Project	IEEE 802.16 Broadband Wireless Access Working Group < http://ieee802.org/16 >	
Title	Service Primitives for Location Update	
Date Submitted	2005-07-20	
Source(s)	Yun Won Chung, PhD Jee Hyeon Na, Sang Ho Lee, PhD ETRI, 161, Gajeong-dong, Yuseong-gu, Daejeon, 305-700, Korea	yun.chung@etri.re.kr jhna@etri.re.kr leesh@etri.re.kr Voice: +82-42-860-5244 Fax: +82-42-861-1966
Re:	Call for Comment on P802.16g Baseline Document	
Abstract	This contribution proposes service primitives for location update.	
Purpose	The document should be considered during the resolution of comments on the baseline document.	
Notice	This document has been prepared to assist IEEE 802.16. It is offered as a basis for discussion and is not binding on the contributing individual(s) or organization(s). The material in this document is subject to change in form and content after further study. The contributor(s) reserve(s) the right to add, amend or withdraw material contained herein.

Service Primitives for Location Update

Yun Won Chung, Jee Hyeon Na, and Sang Ho Lee

Fig. 2 - Location Update Primitives

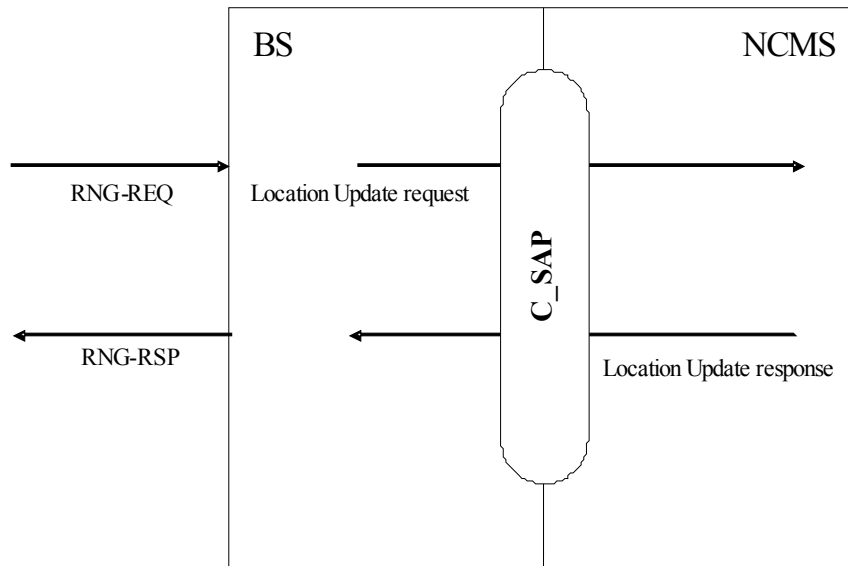
[Modify section 14.5.9.3 as follow]

Figure 2 shows service primitives for Location Update between a BS and an NCMS.
